## Technical Bulletin

Subject: Firmware Release Note: Main			Prepared by: Y. Miyamoto
From: 1st Tech S	Service Sect., MFP/Printer Tech	Service Dept.	
Classification:	Troubleshooting	☐ Part information	Action required
	☐ Mechanical	☐ Electrical	☐ Service manual revision
	☐ Paper path	☐ Transmit/receive	☐ Retrofit information
	☐ Product Safety	Other (Firmware)	☐ Tier 2

Model: Reveil-P1/ Reveil-MF1	Date: 25-May-16	No.: RM290002a

Model: Rev-P1/MF1 Date			Date: 29-No	v-16	No.: RM291003		
Subject: New "Dot coverage" function					Prepared by: Y. Miyamoto		
From: 1nd Tech Service Sect., MFP/Printer Tech Service Dept.							
Classification:  Troubleshooting  Mechanical  Paper path  Product Safety		<ul><li>☐ Part information</li><li>☐ Electrical</li><li>☐ Transmit/receive</li><li>☐ Other (New model)</li></ul>		<ul> <li>☐ Action required</li> <li>☐ Service manual revision</li> <li>☑ Retrofit information</li> <li>☑ Tier 2</li> </ul>

### The new Dot Coverage function

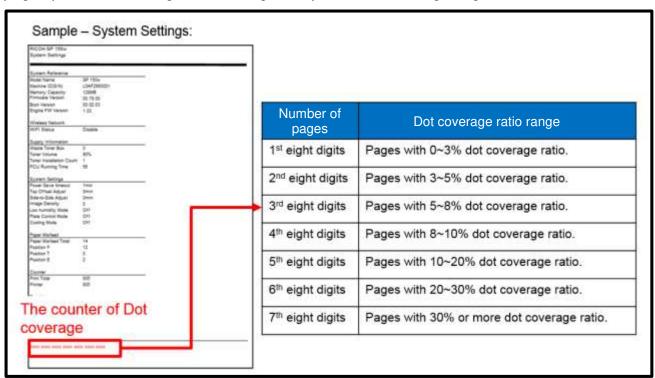
The "Dot coverage" function was newly added, to allow service to verify the dot coverage ratio of the jobs printed in number of pages.

The information can be viewed in System Settings.

The dot coverage ratio is categorized in seven ranges as shown below. The number of pages printed according to each range is represented with eight digit numbers.
